Wisconsin Department of Transportation

Proposal #39: 1016-01-62, WISC 2022379
Tomah - Portage
24th Avenue to Mirror Lake Bridge
IH-90
Juneau and Sauk Counties

This is Addendum No. 01, which provides for the following:

ADDENDUM NO. 01

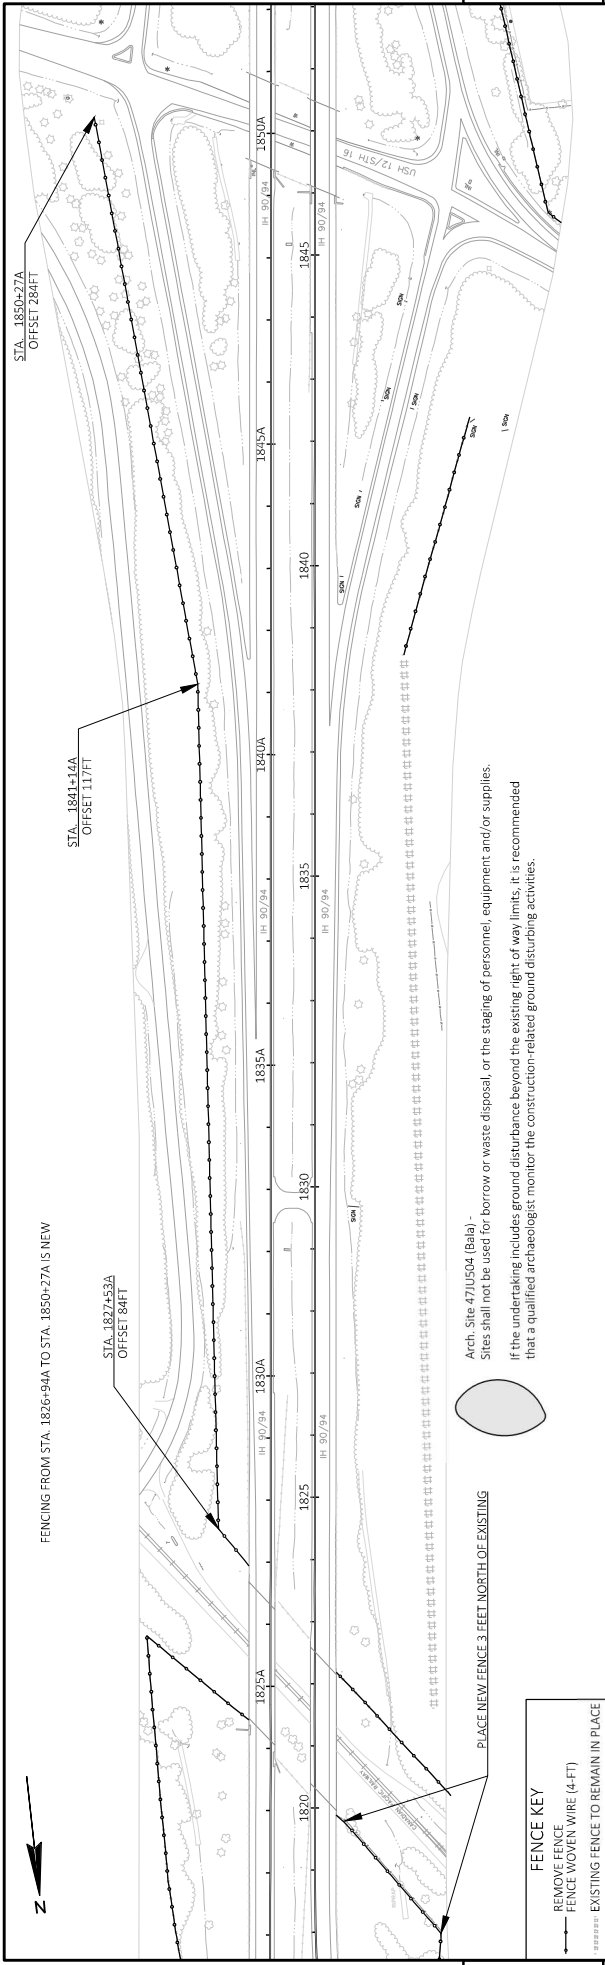
Revised Plan Sheets	
Plan Sheet	Plan Sheet Title (brief description of changes to sheet)
28	Added 2,400 LF of Fence Woven Wire to Miscellaneous Quantities
38	Updated Location of fence replacement in NW quadrant near CP Railroad. Shows location of new fence STA. 1826+94A to STA. 1850+27A.

Revised Bid Item Quantities					
Bid Item	Item Description	Unit	Old Quantity	Revised Quantity	Proposal Total
616.0100	Fence Woven Wire (4.FT)	LF	132,800	2,400	135,200
